HALL & ASSOCIATES

January 8, 2015

**RE: NPDES Permit No.: MA0100897
Public Notice Number: MA-010-13
Taunton, MA
Supplemental Comments on Draft Permit**

Figure 1

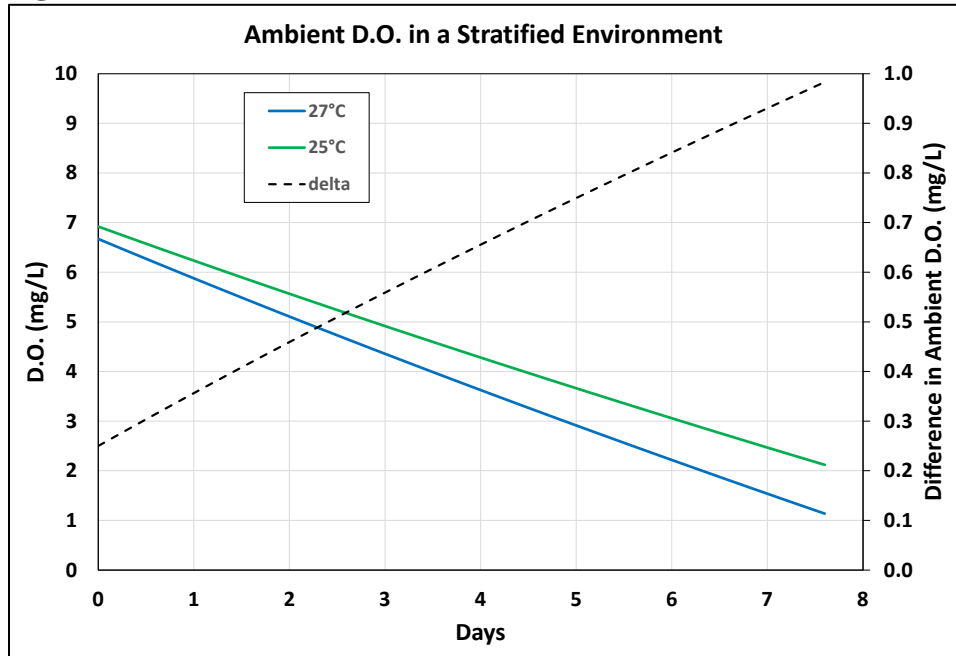
The influence of these changes on ambient D.O. concentration can be illustrated using a simple model that EPA commonly employs to estimate D.O impacts on natural waters. For example, suppose the receiving water is saturated and then becomes stratified so that re-aeration does not replenish the dissolved oxygen lost to oxidation (i.e., the situation in Mount Hope Bay that leads to oxygen depletion in the water column). Under this circumstance, the D.O. concentration in the bottom waters gets reduced over time as CBOD decay and SOD are exerted. Figure 1 illustrates the difference in ambient dissolved oxygen as the stratification condition persists, for the case with the water column at 27°C and the water column 2°C cooler. In this case, the ultimate CBOD of the receiving water is estimated at 5 mg/L, the decay rate is 0.05/day at 20°C, carbonaceous oxidation follows first order decay, and the SOD is 1.0 g/m²/d at 20°C for the initial condition (T = 27°C). Under the alternate condition (T = 25°C), the baseline SOD is reduced from 1.38 g/m²/d to 1.26 g/m²/d (a decrease of 9 %) based on the change in temperature. The actual decrease in SOD would likely be greater considering the reduction in algal growth and settling.

This analysis shows the gradual buildup of deficit as the time of stratification is prolonged. In this case, a difference of only 2°C can exert an excess deficit exceeding 0.5 mg/L in less than three days. This example is presented not to predict the precise effect in Mount Hope Bay but to illustrate that the estimated change in temperature is expected to significantly influence the D.O. regime in several, well documented ways. This influence will change the level of impairment in the Estuary and thereby alter the degree of TN reduction necessary to restore the designated use, assuming that the Sentinel Method was appropriate for making such an assessment. The water transported into the Taunton Estuary from Mount Hope Bay will, to a certainty, have significantly improved D.O. levels due to the improved temperature regime and the Region's analyses need to account for this changed condition.

Consequently, water quality-based effluent limits for the Taunton WWTP must be revisited to account for this fundamental change in conditions influencing the D.O. regime in the Estuary. Given this information, it would be improper to conclude that stringent TN reduction is required to ensure D.O. criteria compliance in the Taunton Estuary, based on data and analyses that failed to account for the effect of eliminating the Brayton Point discharge.
